**FEASIBILITY OF RETROFITTING COOLING TOWERS  
AT  
DIABLO CANYON POWER PLANT UNITS 1 & 2**

APRIL 11, 2003  
RECEIVED 4/17/03

**PREPARED BY:**

**DRAFT**  
**FOR COMMENTS ONLY** Page

FIGURE 3- Parcel P Detail

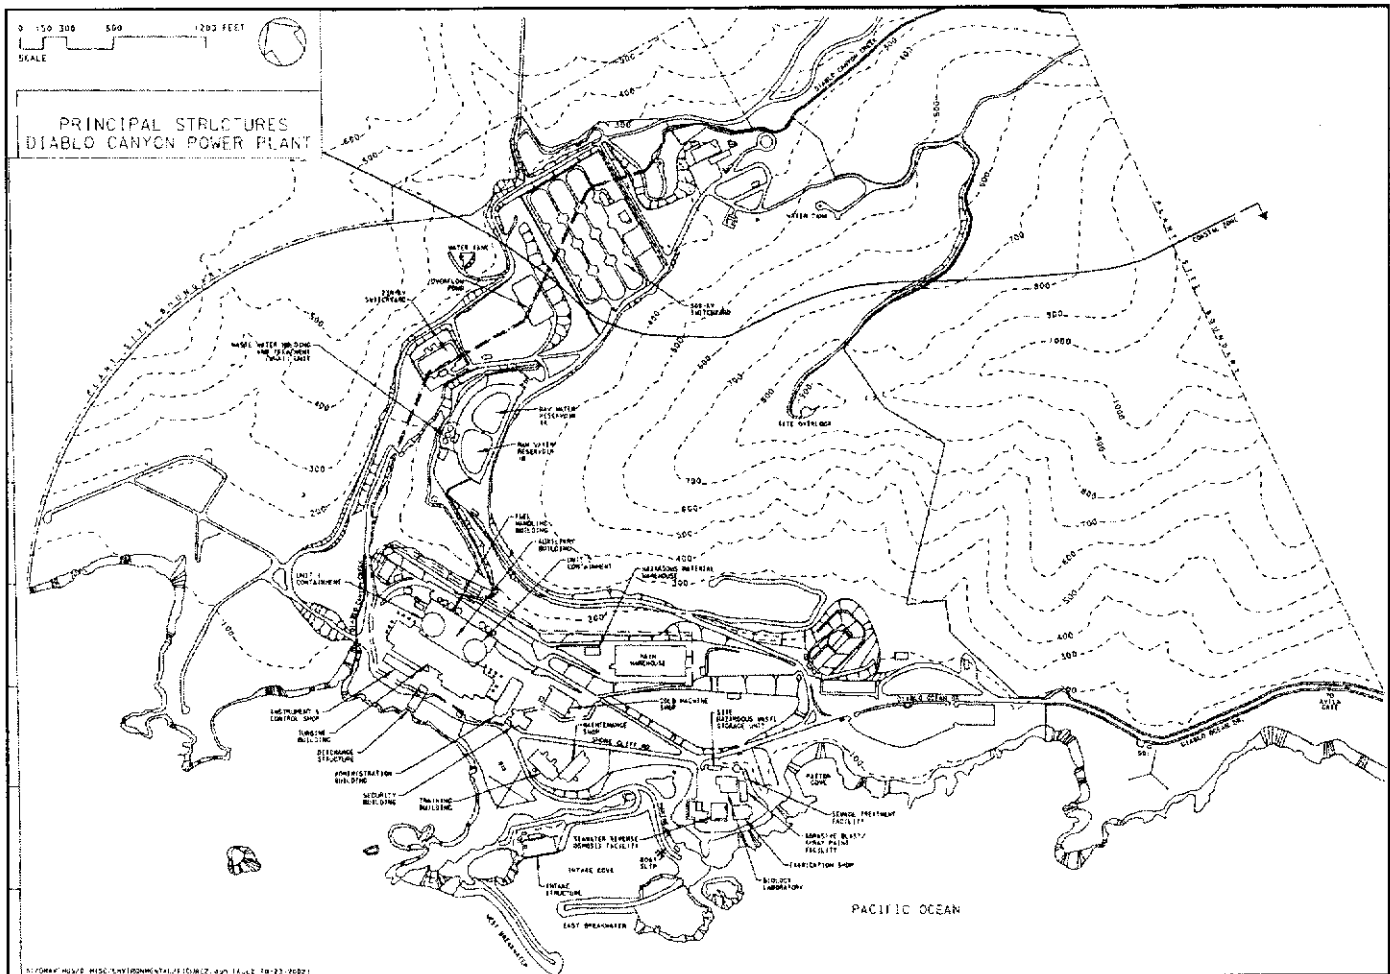
Things get even worse from there. Most of Parcel P is occupied by steep mountains that rise rapidly from the plateau. The summits surrounding Parcel P reach heights of between 1231 feet and 1573 feet. Most of Parcel P is unusable due to its steep gradient (see Figure 3 below).

Roughly 25% of the land in Parcel P is able to support construction. The gradient of the rest is simply too steep. Existing structures and parking lots already occupy nearly all of the usable space.

**FIGURE 4 - Tetra Tech's Proposed Siting of the Cooling Towers[1]  
(This is a duplicate of Figure 2 from Tetra Tech's November 2002 report)**

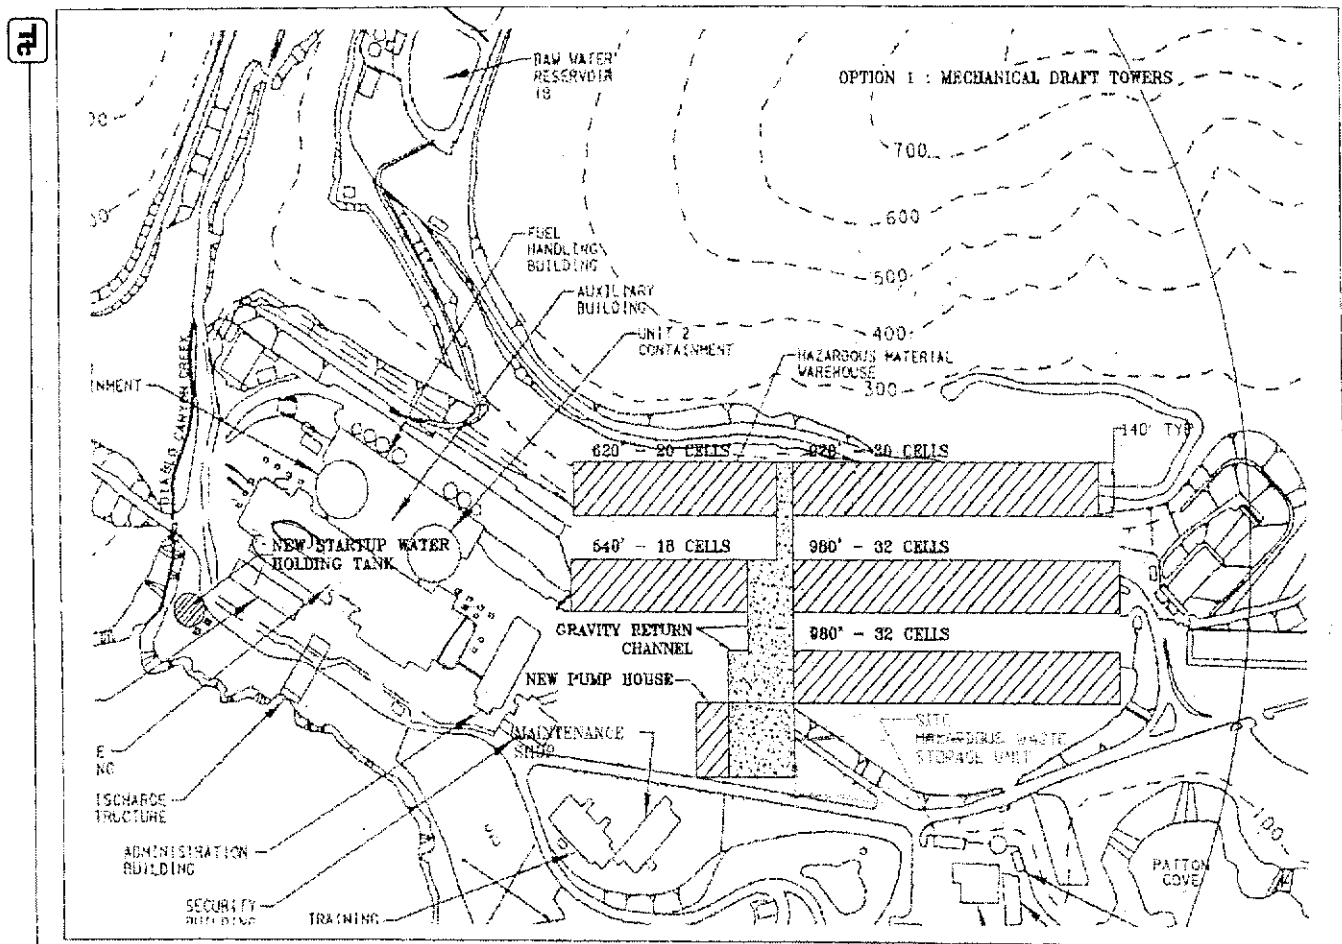
Tetra Tech has proposed displacing a substantial area in the center of the marine terrace for construction of the cooling towers (see below). Each of the cooling towers proposed have a 60' x 60' footprint. The total area required would be roughly 1600' long and 600' wide. The construction would be a massive project, extremely costly in terms of both money and time.

Tetra Tech’s proposed cooling tower build site is currently occupied by the warehouse, the machine shop, main parking lots 7 & 8, and the access road and transportation route. The warehouse is not a simple building as the name implies. It is a permanent structure 475’ X 207’[8] that stores parts required for plant operations & maintenance and also provides a number of offices. The only area large enough to accommodate the warehouse inside the industrial area is located across from the reservoirs on land already claimed for a used fuel storage area.

This bank of 132 cooling towers would eliminate current means of transport and access to the plant and would require major changes. The access road that would be destroyed to make way for the new cooling towers is the engineered route taken to carry the very heavy spent nuclear fuel casks to the site storage area. For safety reasons, such a road may not have a gradient exceeding six percent. With the leveling of the area to build the cooling towers, it is hard to conceive how the access road could be redesigned to remain serviceable. Further,

**FIGURE 5 - Gradient Between Parking Lot & Warehouse.**

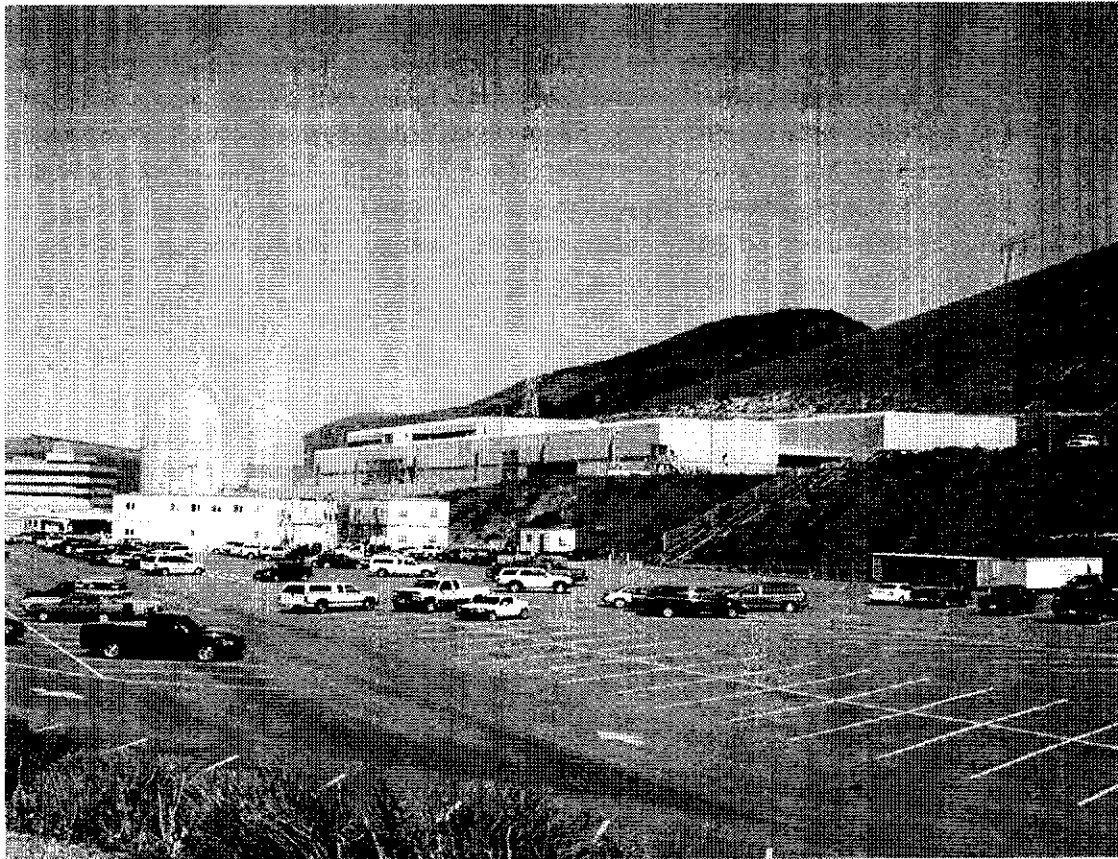
The parking lot area is “underlain by a thick sequence of older colluvial fan deposits consisting of gravelly clay colluvium up to about 60 feet thick.”[7] To prepare the site, pilings penetrating this level would need to be installed to maintain ground stability.

This area between the main parking lots 7&8 would need to be leveled to accommodate the proposed cooling towers as opposed to maintaining its current terraced configuration. Towers could not be built on the two existing terraces because exhaust from the lower level (where the current main parking lot stands) would too easily recirculate into the cooling towers on the upper level and destroy their ability to supply any cooling.

**FIGURE 8- Salt Drift Patterns from Tera Corporation Report, lb/acre-yr  
(In contrast, typical ambient salt deposition from ocean ~86 lb/acre-year)**

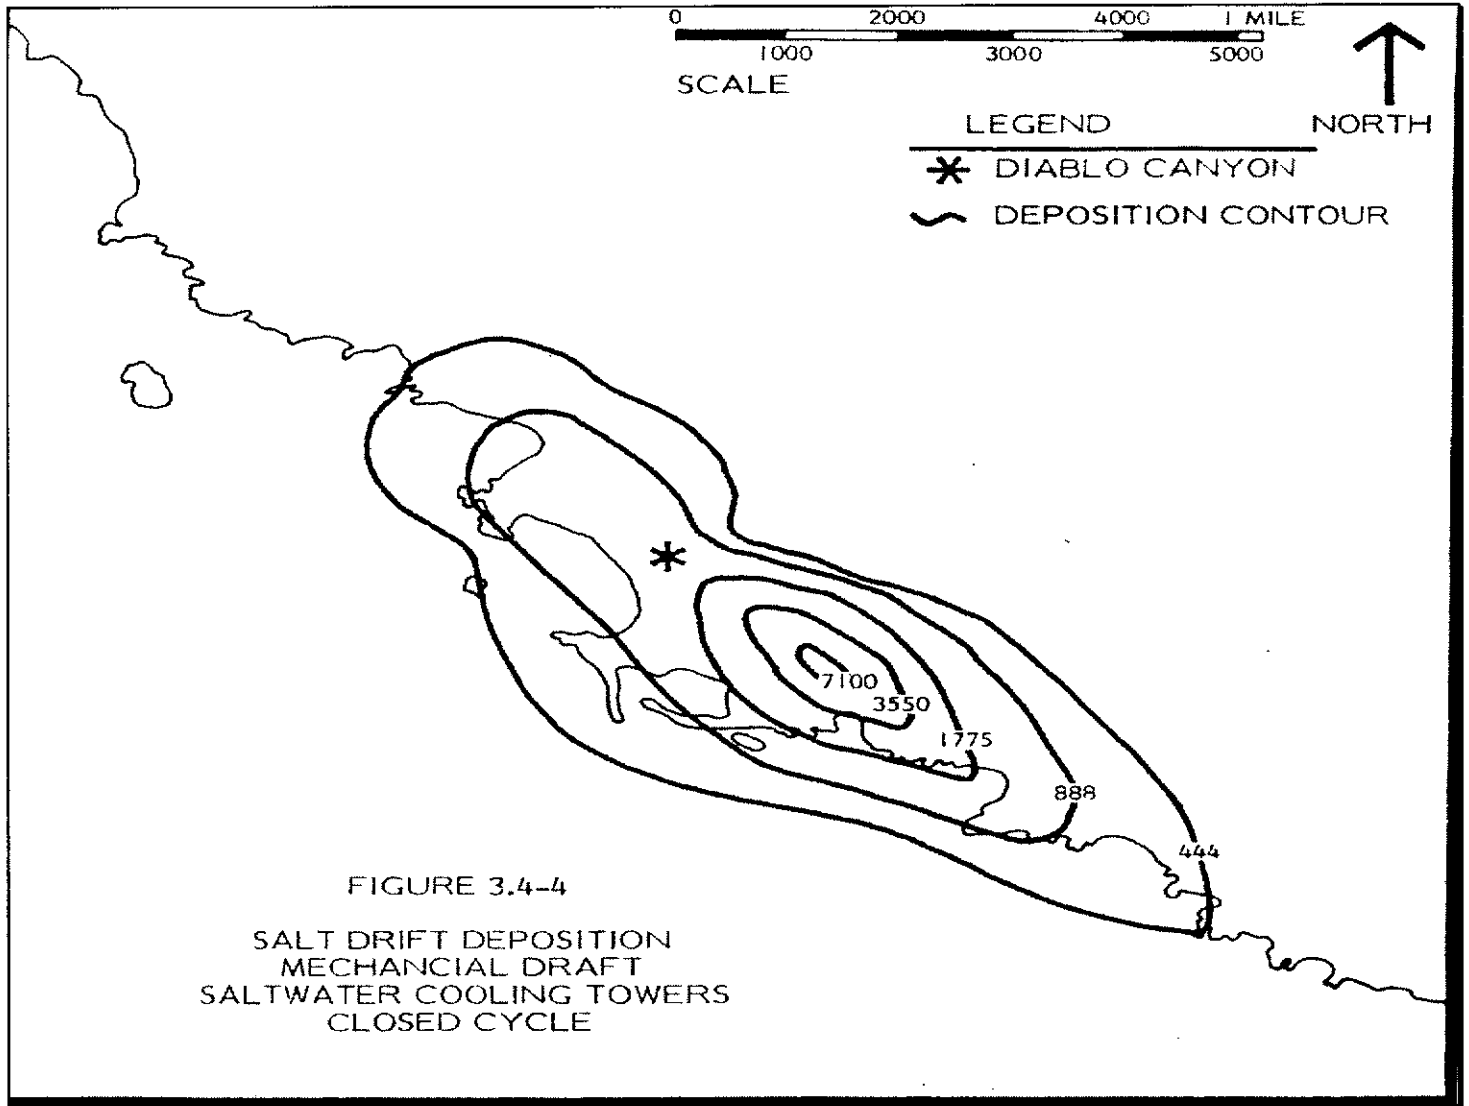
Tera Corp. [14] has modeled likely patterns of drift for mechanical draft cooling towers sited in the general area proposed by Tetra Tech for the cooling towers. See Figure 6 on the following page. Salt will blanket an area extending beyond the plant boundary to the north and south. The center of highest salt deposition will occur approx. 1/3 mile south of the cooling towers within the plant boundary at the southeast section of parcel P. However, a substantial amount will settle over the agricultural zone as well.

As a figure for comparison, salt deposition along the ocean shoreline is only about 86 lb/acre per year [12]. Even the lowest concentration boundary of the Tera study shows a salt concentration of more than five times the natural salt deposition from the sea. Salt will disperse beyond this outer boundary in concentrations lower than that figure, but, given the massive volume of salt, it will impact the local terrestrial ecosystem in the areas surrounding the plant even beyond Parcel P.
